UNITED STATES PATENT AND TRADEMARK OFFICE

APPLICATION NO.	FILING DATE	FIRST NAMED INVENTOR	ATTORNEY DOCKET NO.	CONFIRMATION NO.
10/646,478	08/22/2003	Daisuke Kawagoe	884.937US1	9311

Office Action Summary

DETAILED ACTION

FIG. 7

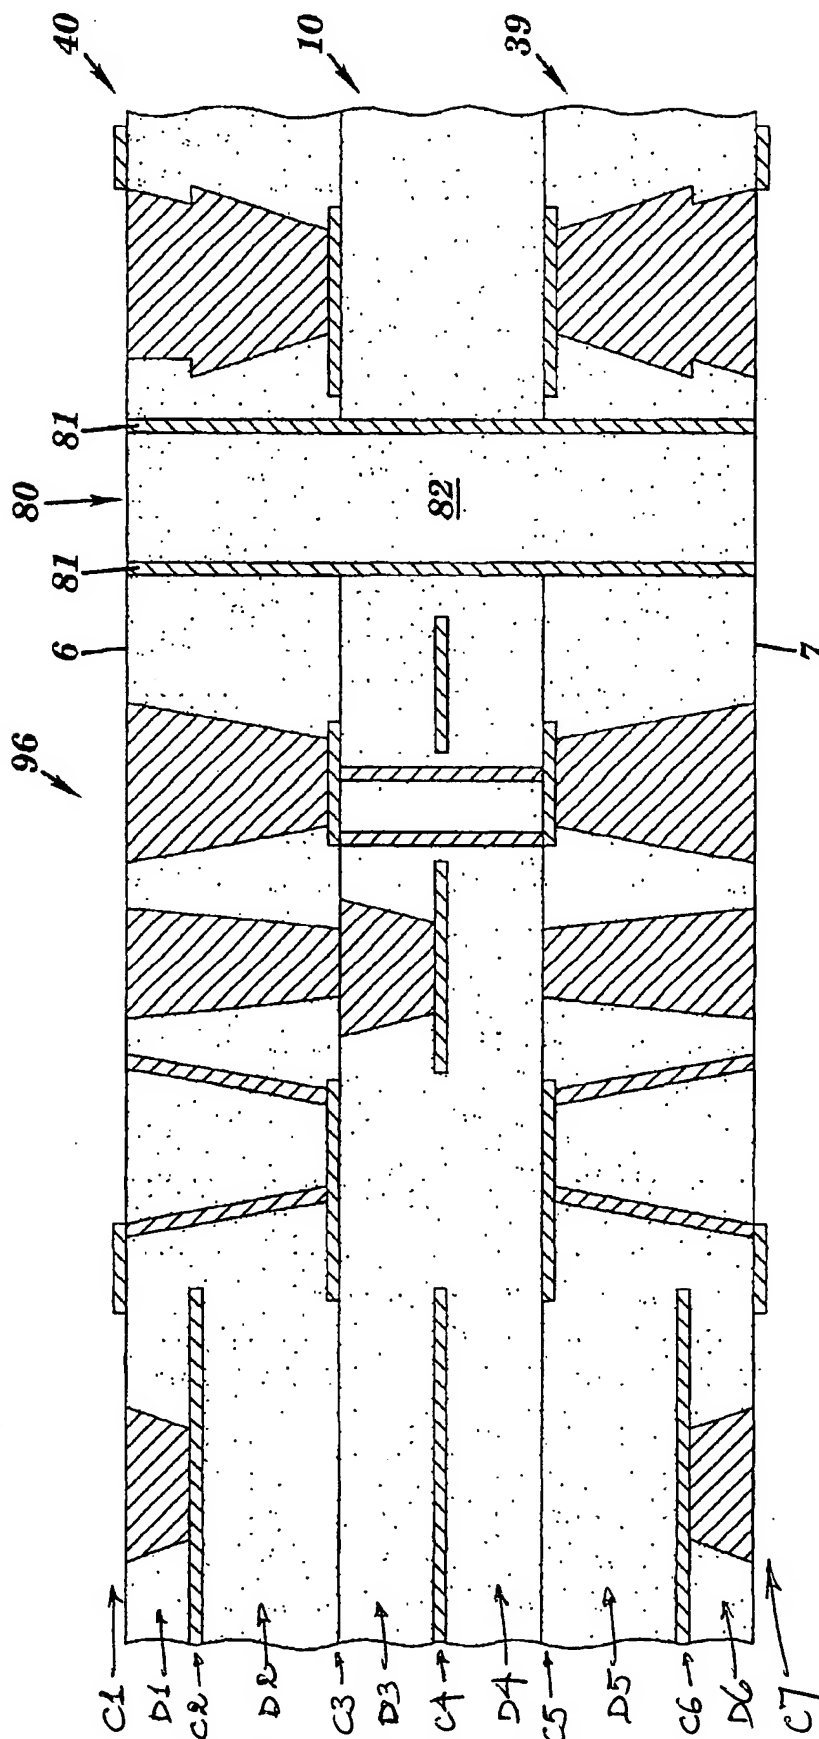
Regarding claim 31, Carpenter et al., in another embodiment of figure 7, (figure 7 with marked elements as shown in attachment "A"), discloses a substrate comprising:

a first conductive layer (C3) between a first dielectric layer (D2) and a second dielectric layer (D3), the first conductive layer including a first skip via (V1) extending through the first dielectric layer (D2) and a third dielectric layer (D1); and a second conductive layer on a fourth dielectric layer (D4), the second conductive layer including a second skip via (V2) extending through the second dielectric layer and the fourth dielectric layer (D4), the first skip via and the second skip via being stacked on top of one another (see figure 7, appendix A).

Regarding claim 32, Carpenter et al., further discloses the first skip via (V1) includes a longitudinal axis (longitudinal axis passing through via V1) and the second skip via (V2) includes a longitudinal axis (longitudinal axis passing through via V2), the longitudinal axis of the first skip via being substantially aligned with the longitudinal axis of the second skip via (see figure 7, appendix A).

Regarding claim 33, Carpenter et al., further discloses the first (D2), second (D3), third (D1) and fourth (D4) dielectric layers are formed on a core (D6) and the first (C3) and second conductive layers (C5) are formed on the core (D6).

Regarding claim 34, Carpenter et al., further discloses the second conductive layer (C5) is between the fourth dielectric layer (D4) and a fifth dielectric layer (D5).

Regarding claim 37, Carpenter et al., further discloses the first conductive layer is a patterned conductive layer and the second conductive layer is a patterned conductive layer (see figure 7, appendix "A").

Regarding claim 35, Carpenter et al., discloses all the features of the claimed invention, as applied to claim 35 above, the embodiment of figure 7 (elements marked on figure 7 in attachment "A"), including a third conductive layer (C6) on the fifth dielectric layer (D5), a third via (V3) extending through the fifth dielectric layer, the third via (V3) being stacked onto the first skip via (V1) and the second skip via (V2).

Regarding claim 36, Carpenter et al., further discloses the first (V1) and second (V2) skip vias each include a longitudinal axis (axis passing longitudinally through the vias) and the third via includes a longitudinal axis (axis passing longitudinally through the via), the longitudinal axis of the first skip via being substantially aligned with the longitudinal axis of the second skip via and the longitudinal axis of the third via (see figure 7, appendix "A").

Regarding claim 38, Carpenter et al., discloses all the features of the claimed invention, as applied to claim 31 above, in the embodiment of figure 7 (with the elements as marked on figure 7 in attachment "A") including the second skip via (V2) as a cylindrical via, but does not disclose the first skip via as a cylindrical via. Also, Carpenter et al., is silent about the diameters of both the vias. However, as can be seen

from figure 7, both cylindrical and tapered via holes are known in the art. Also, cylindrical via holes made using drilling method are well known in the art.
